TO: HONORABLE CHAIRMAN AND PLANNING COMMISSION
FROM: RON WHISENAND, COMMUNITY DEVELOPMENT DIRECTOR
SUBJECT: TENTATIVE PARCEL MAP PR 06-0236, AT 2225 PARK STREET
(APPLICANT: LEGACY PARK PARTNERS, LLC)
DATE: FEBRUARY 27, 2007

Needs: For the Planning Commission to consider a Parcel Map application filed by Craig R. Smith Architects, on behalf of Legacy Park Partners, LLC, to subdivide a 12,585 square foot parcel into four parcels.

Exhibit I
Unit A Exterior Elevations
PR 06-0236
(Legacy Partners, LLC)

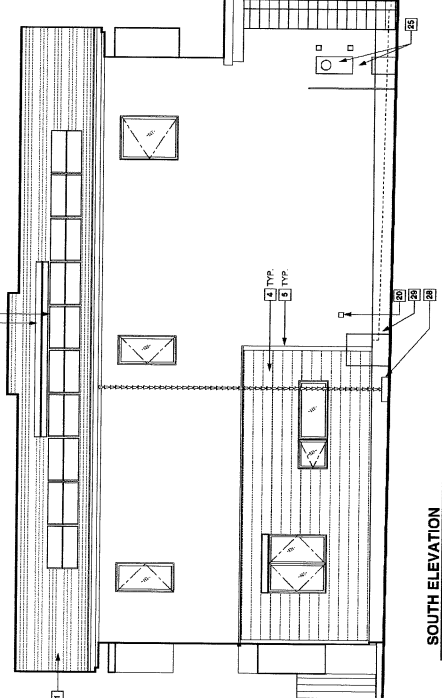
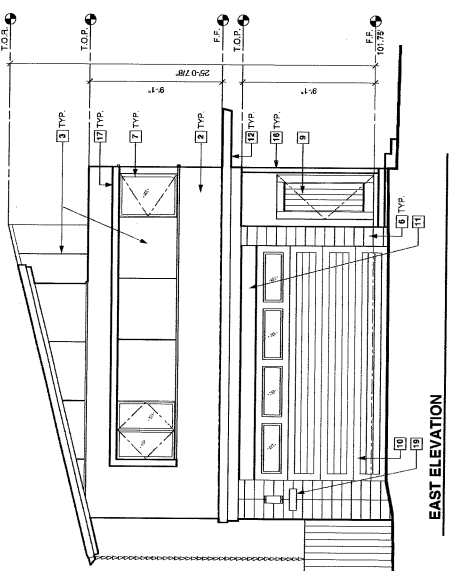
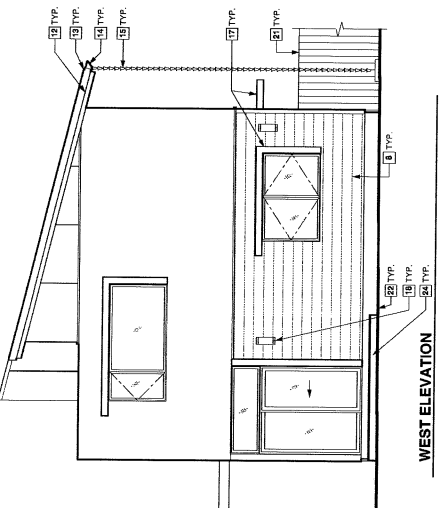
8. The DRC had concerns with the architecture of the four homes; The Committee did not feel that the proposed architecture fit in with the character of this area of town. The Committee did not take action on the project and suggested that the project go forward for review and discussion by the full Commission.

The question for the Planning Commission to consider is whether the project would meet the General Plan policy of providing an innovative site and building design that promotes architectural and design excellence. In addition, the Commission should decide whether the design is compatible with other dwellings in the neighborhood which range in character.
